MONTICELLO NUCLEAR GENERATING PLANT

Amendment No. 20  
License No. DPR-22

ATTACHMENT TO LICENSE AMENDMENT NO. 20

SUPPORTING AMENDMENT NO. 20 TO PROVISIONAL OPERATING LICENSE NO. DPR-22

Figure 3.11.2

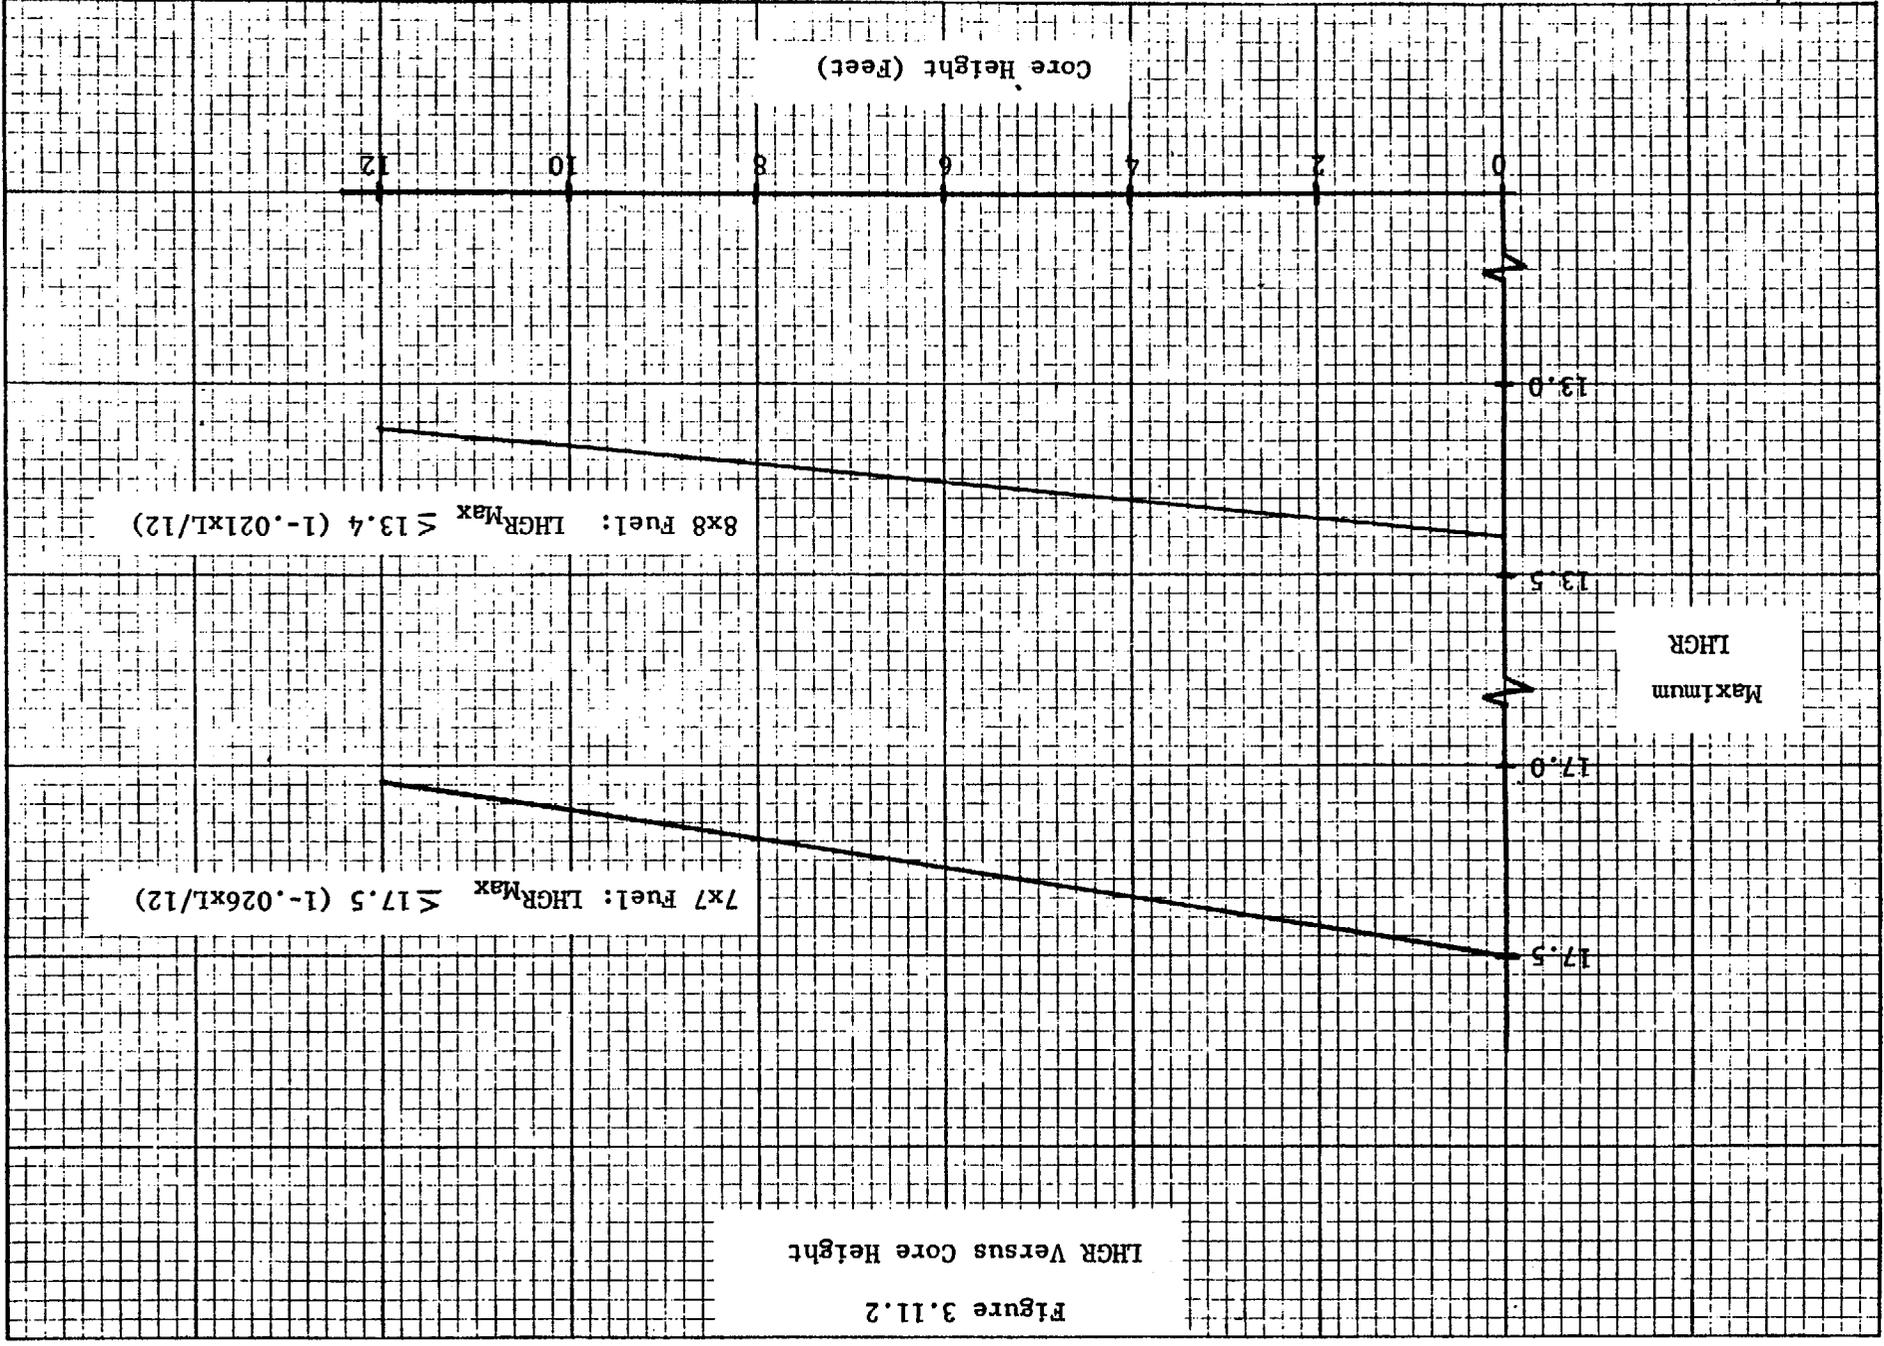
During power operation, the LHGR as a function of core height shall not exceed the limiting value shown in Figure 3.11.2. If at any time during operation it is determined that the limiting value for LHGR is being exceeded, action shall be initiated within 15 minutes to restore operation to within the prescribed limits. Surveillance and corresponding action shall continue until reactor operation is within the prescribed limits. If the LHGR is not returned to within the prescribed limits within two (2) hours, the reactor shall be brought to the Cold Shutdown condition within 36 hours.

Figure 3.11.3  
 $K_f$  Factor Versus Percent  
of Rated Core Flow

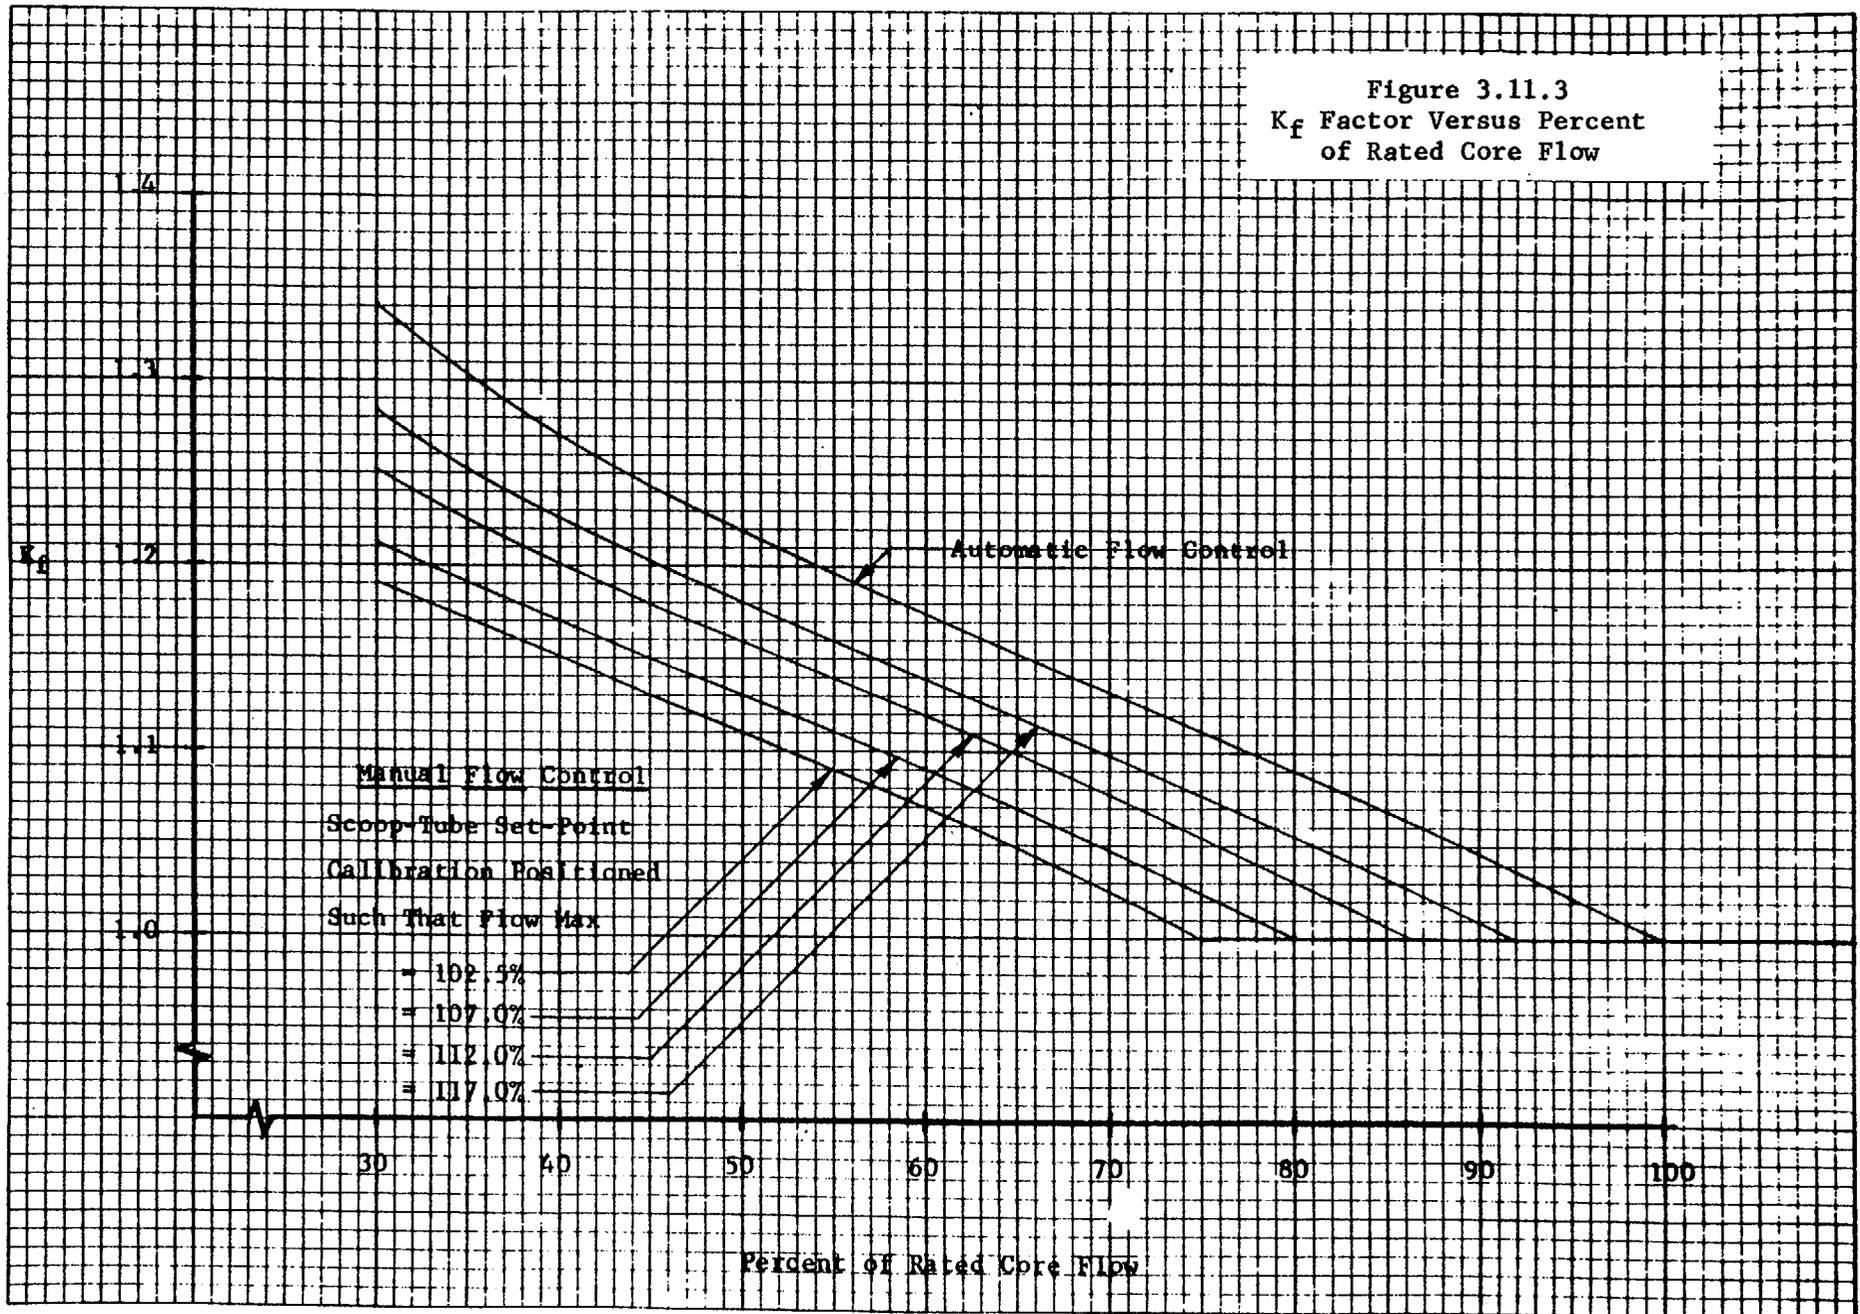
During power operation, the Operating MCPR Limit shall be  $\geq 1.38$  for 8x8 fuel and  $\geq 1.29$  for 7x7 fuel at rated power and flow. If at any time during operation it is determined that the limiting value for MCPR is being exceeded, action shall be initiated within 15 minutes to restore operation to within the prescribed limits. Surveillance and corresponding action shall continue until reactor operation is within the prescribed limits. If the steady state MCPR is not returned to within the prescribed limits within two (2) hours, the reactor shall be brought to the Cold Shutdown condition within 36 hours. For core flows other than rated the Operating MCPR Limit shall be the above applicable MCPR value times  $K_f$  where  $K_f$  is as shown in Figure 3.11.3.
